FLIGHT READINESS STATEMENT
STS-65/ET-64 & STS-68/ET-65
DELTA LEVEL III REVIEW
EXTERNAL TANK PROJECT

ET Project

Block 11 and STS-64/ET-66 Flight Readiness Review

MARTIN MARIETTA
MANNED SPACE SYSTEMS

LO2 Tank CDF Manifold Electrical Bonding (B01949)

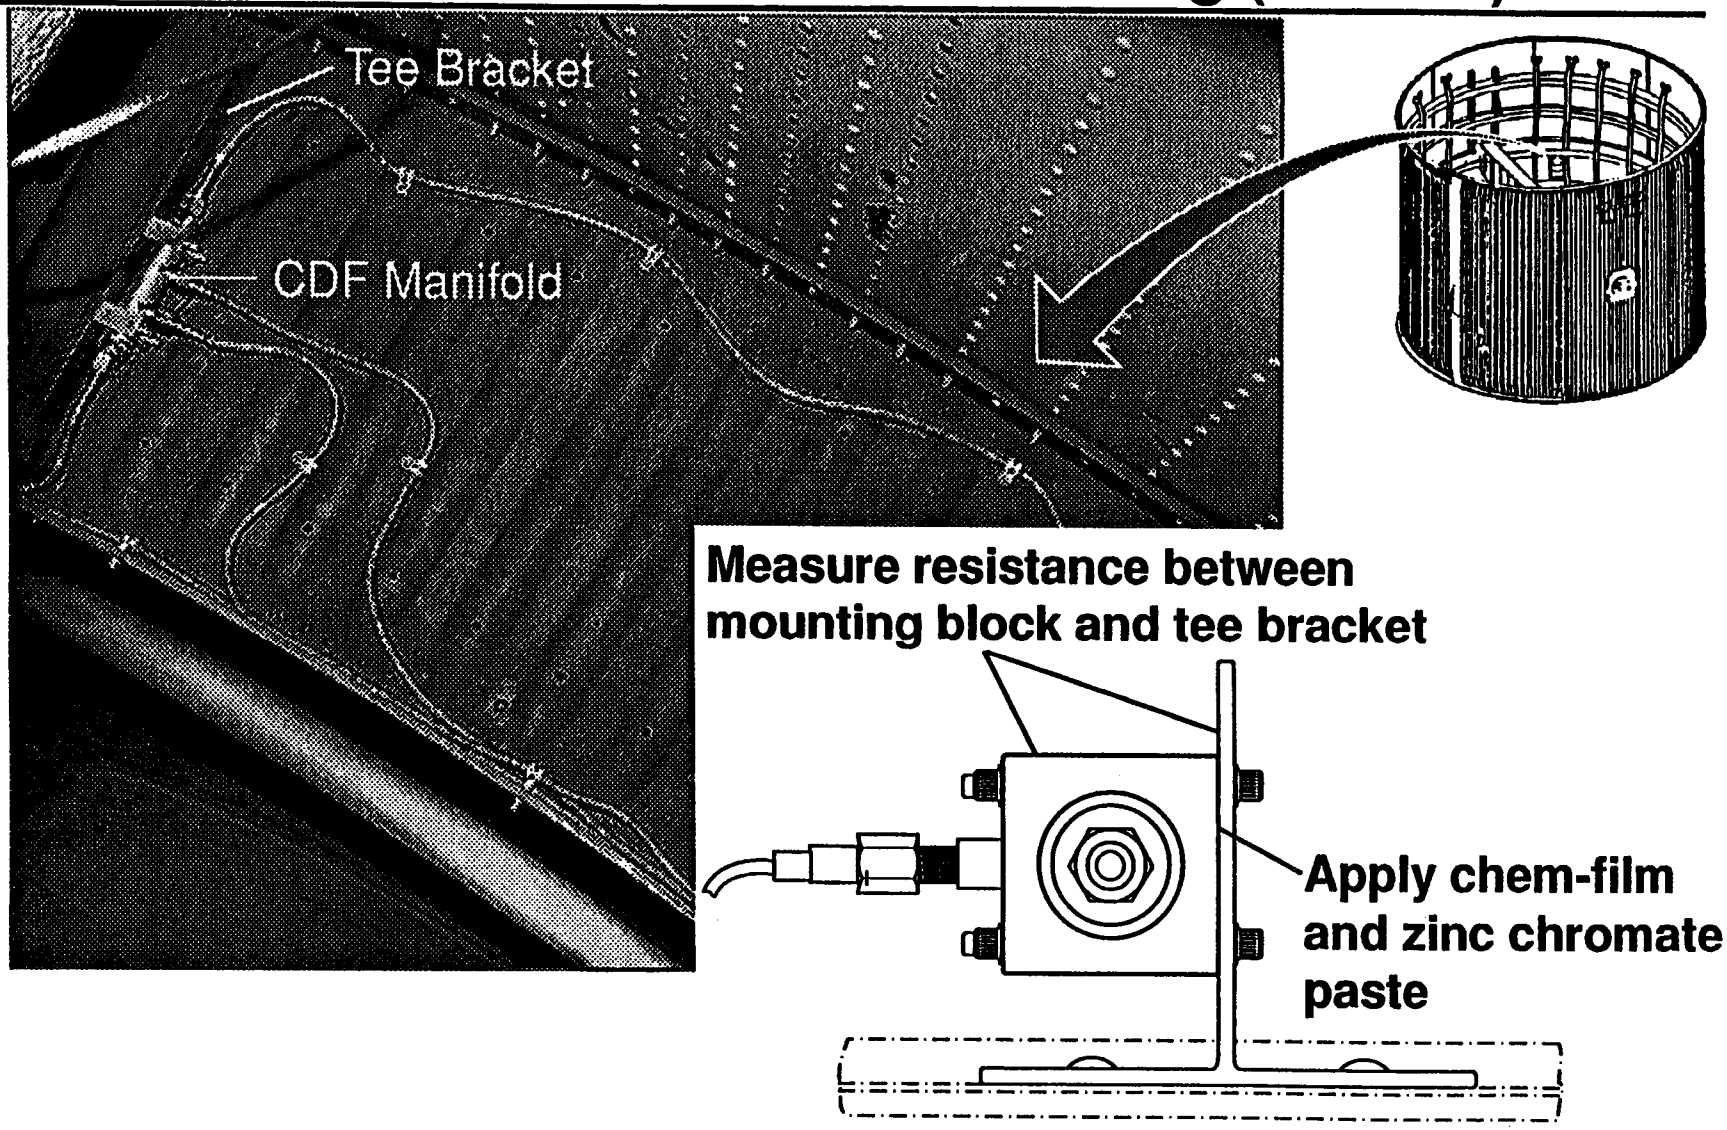
- Abraded Confined Detonating Fuse (CDF) manifold to remove anodized coating
- Removed primer from ring stiffener
- Applied chem-film and zinc chromate paste to faying surfaces
- Implemented post CDF manifold installation electrical bond checks

- CDF manifold bonding requirements not consistent with installations on other Shuttle elements
  - No requirement existed in MIL-B-5087 that would require CDF manifold bonding
  - Results of TIM agreed that no requirements existed, however, it would be desirable to implement bonding requirements on future CDF manifold installations

- Test - Electrical bonding checks verify bond resistance ≤ 2.5 milliohms
